CITY OF ALBUQUERQUE

RE: **Lot 9 Block 13 Unit 5 SAD 227**
6519 Jade Dr. NW
Grading and Drainage Plan
Engineers Stamp Date 7/19/2021 (E10D62)

Based upon the information provided in your submittal received 7/19/2021, this plan cannot be approved for Grading Permit until the following comments are addressed.

TITLE:			
GRADING PLAN			
Design Review Committee	City Engineer	Mo./Day/Yr.	Mo./Day/Yr.
City Project No.	Zone Map No.	Sheet	Of
	E-10-Z	1	2

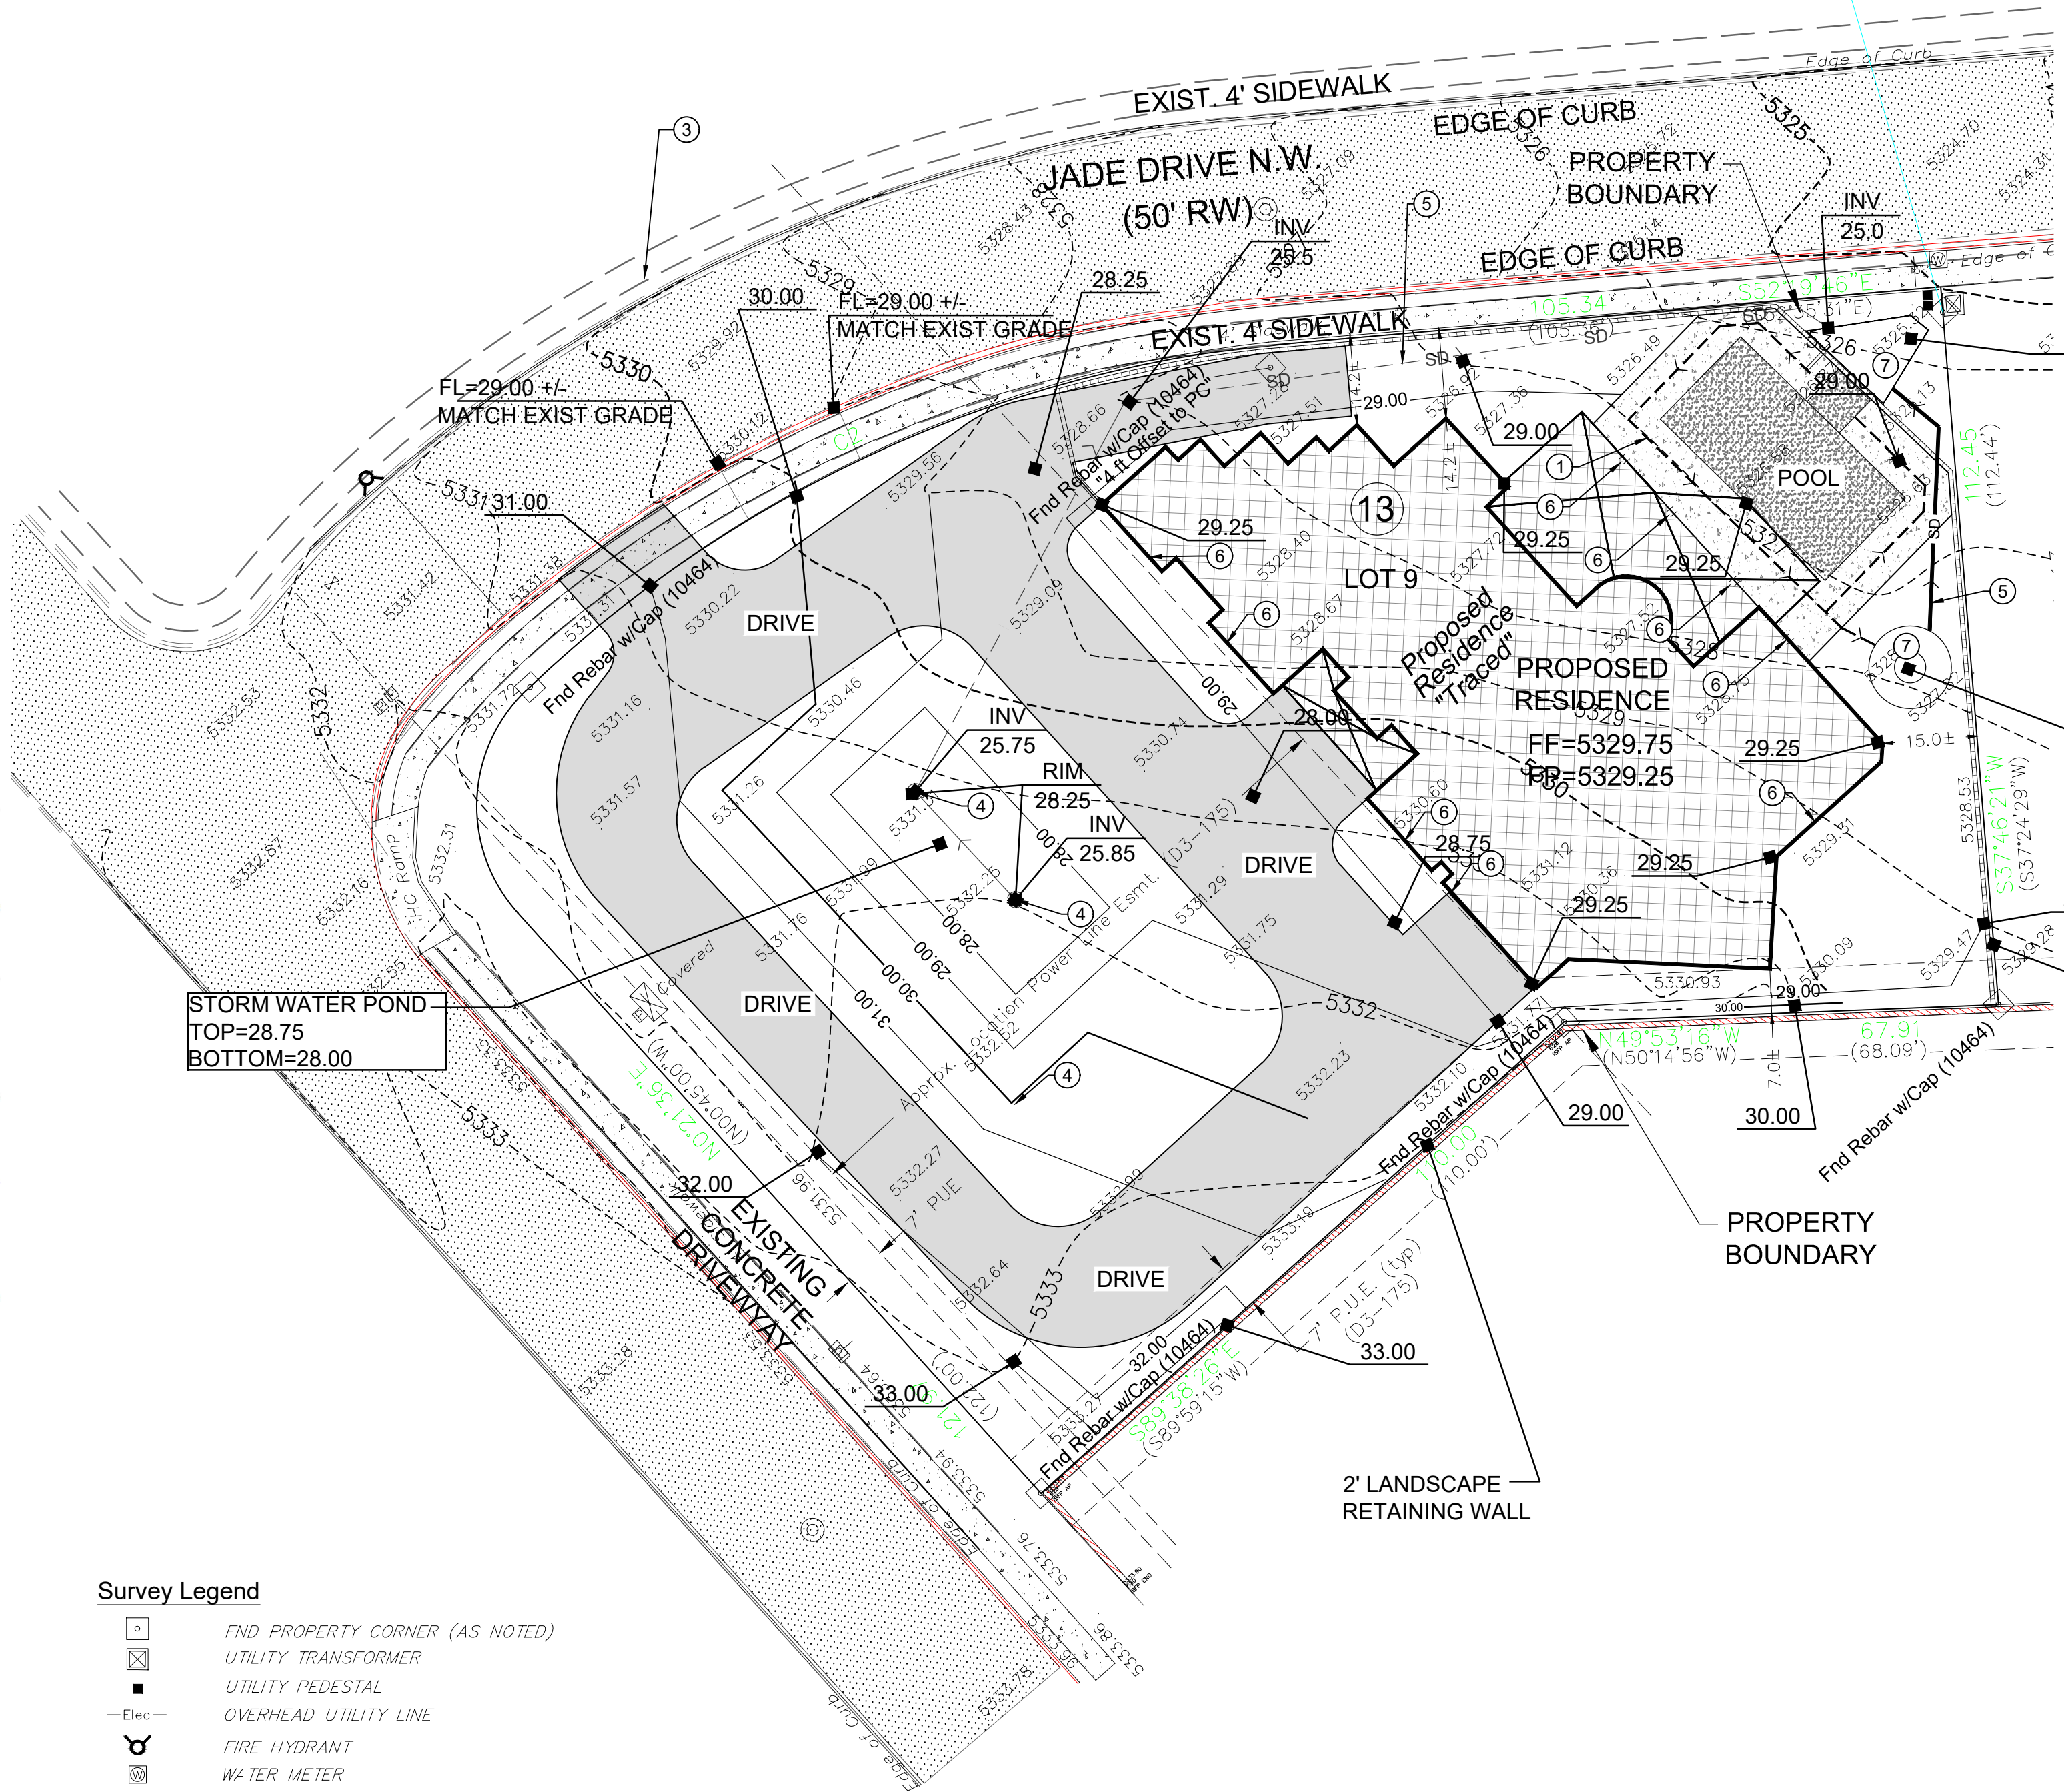
- Provide the Area map and the FIRM map.
- Inform Owner/Contractor not to use dirt as a ramp to climb curbing or drive over the sidewalk. Only crusher fines or lumber may be used for this process.
